Alton Coal Development, LLC

**Re: Coal Hollow Mine and North Private Lease Bond Adjustment Permit
Amendment, Alton Coal Development, LLC, Coal Hollow Mine, Kane
County, Utah, C/025/0005 Task ID #5916**

Alton Coal Development, LLC (ACD) is submitting this response derived from deficiencies received in Task ID # 5916 for an amendment to the MRP to adjust the calculations by which reclamation liability is determined and bonded for the Coal Hollow Mine permit areas. This adjustment is requested under Utah Code found at R645-301-830.410-430. The rules state:

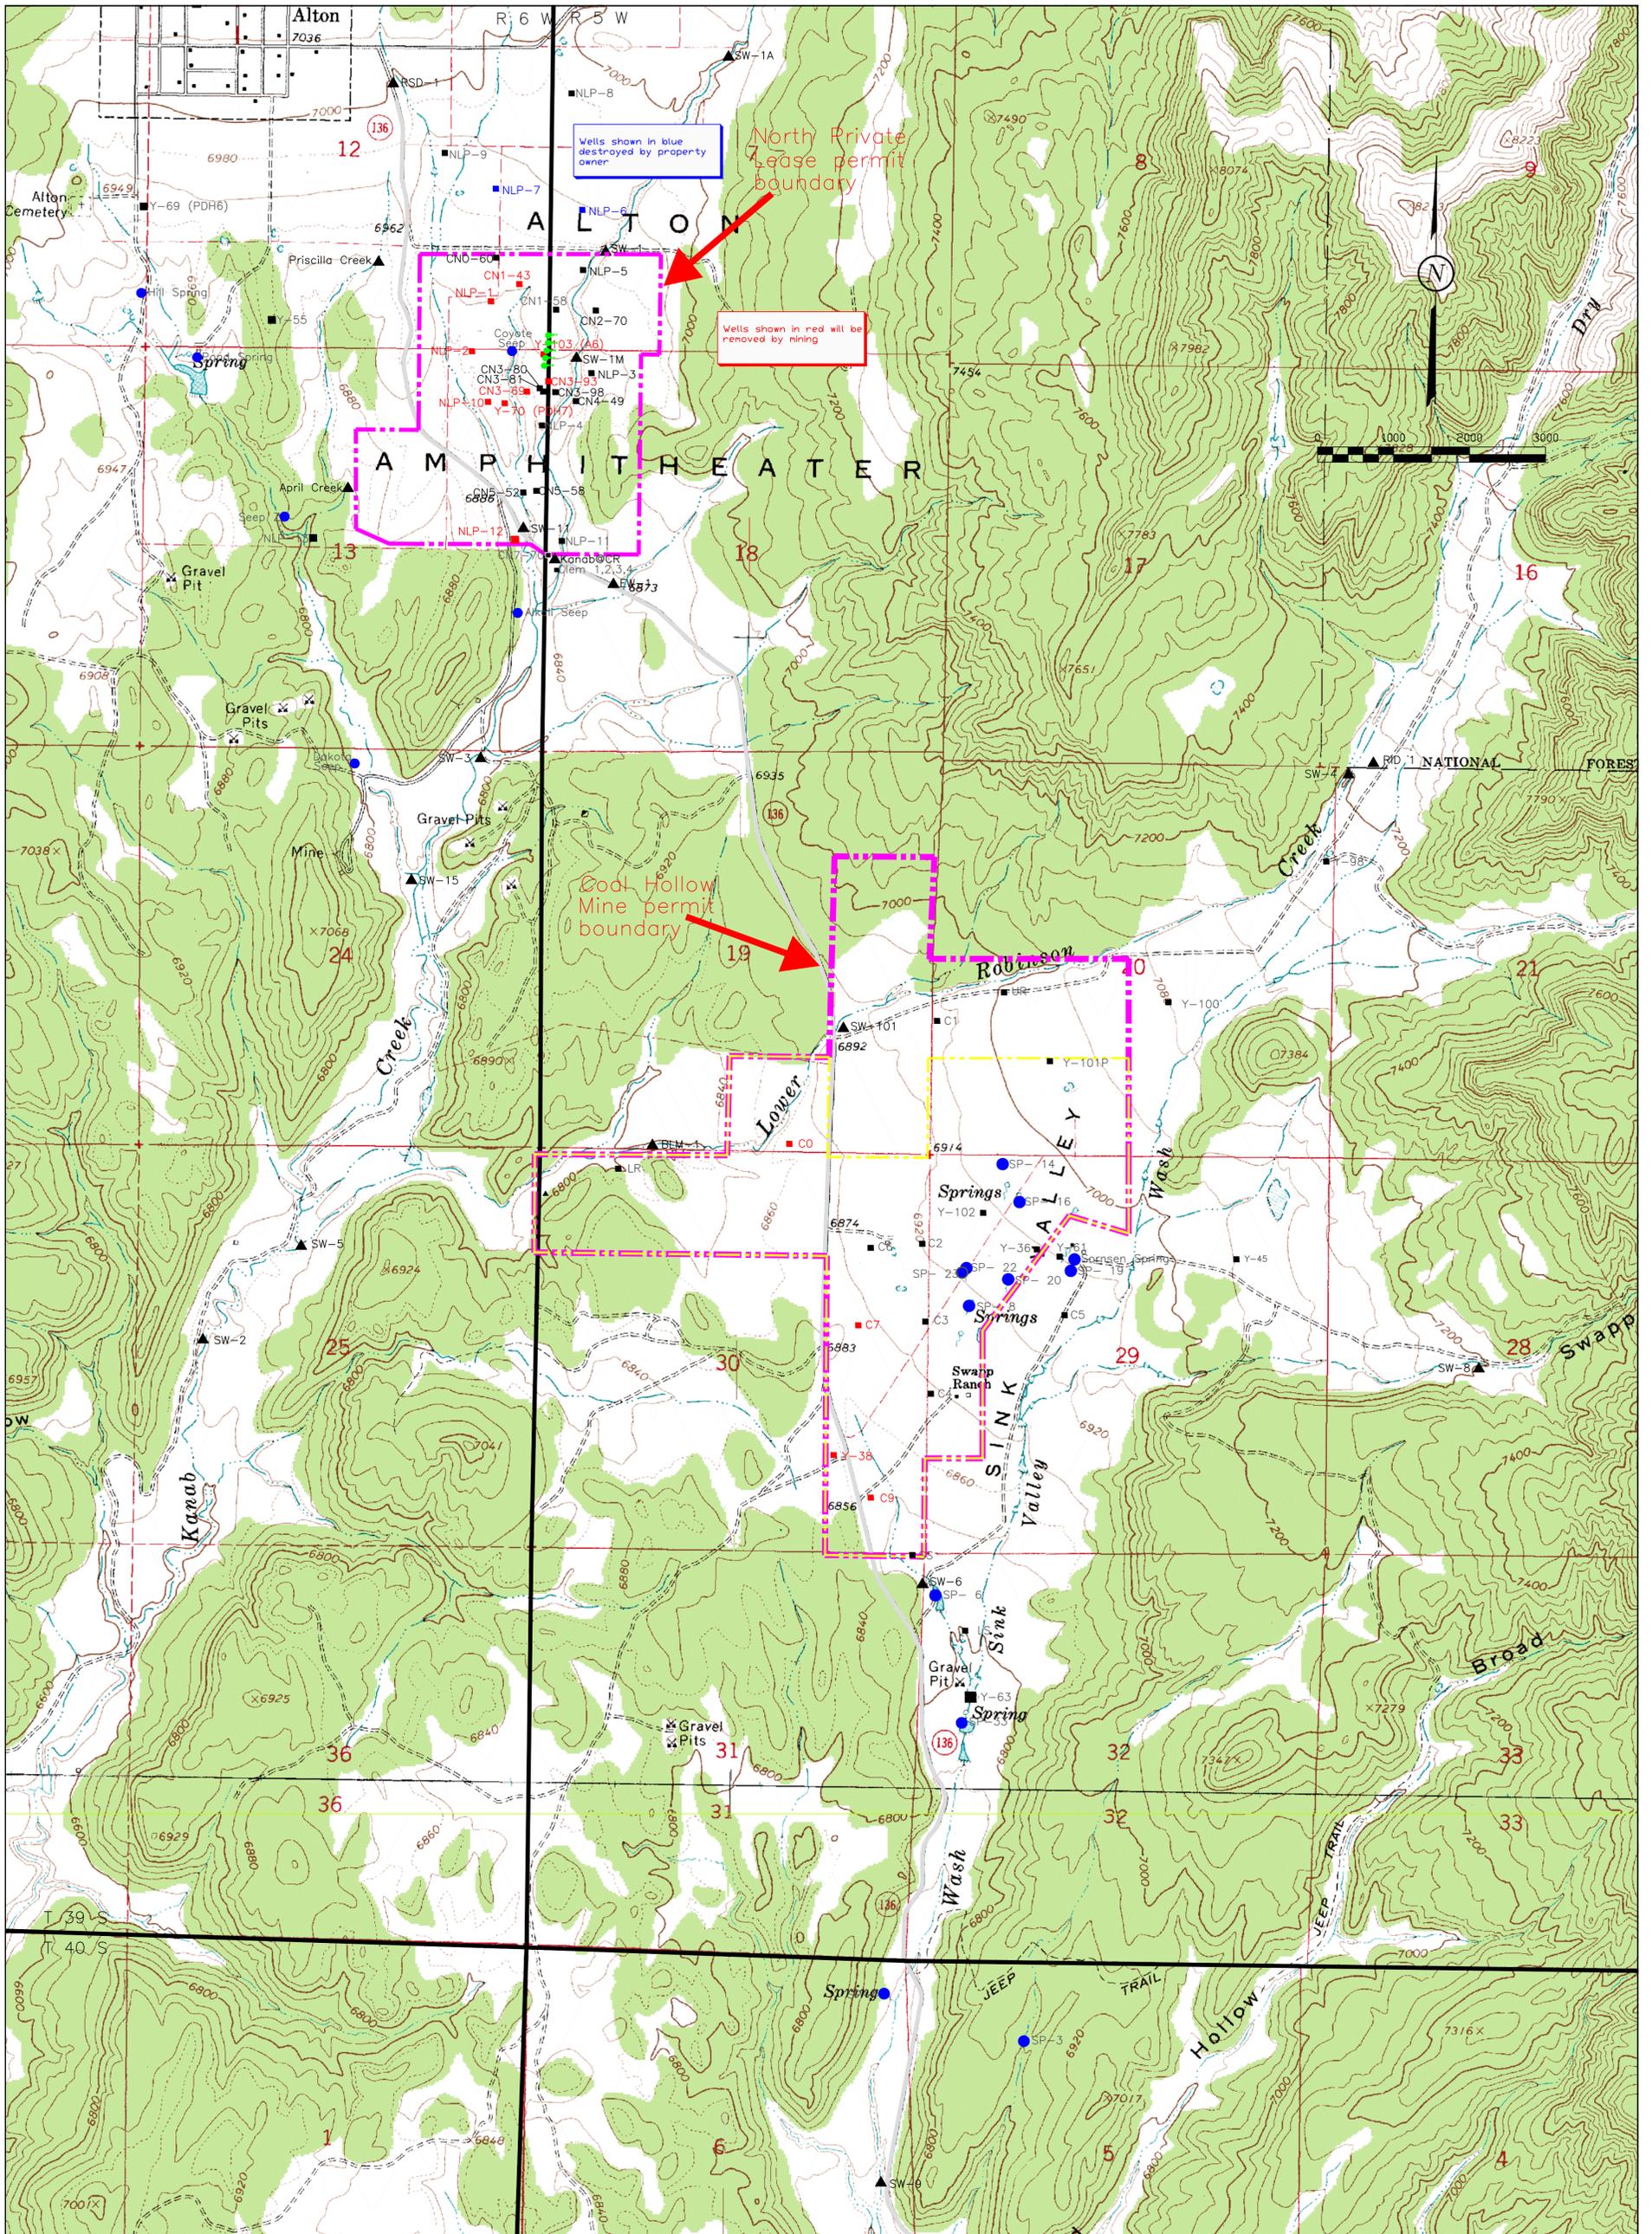
The amendment must also update Drawing 7-10 "Water Monitoring Locations". The updated map must show the location of the dewatering wells and indicate if the wells will be mined through or not. The 'Table 7-10 Summary information for wells' must be updated to include all information on these wells.

Drawing 7-10 and Table 7-10 have been updated with dewatering wells.
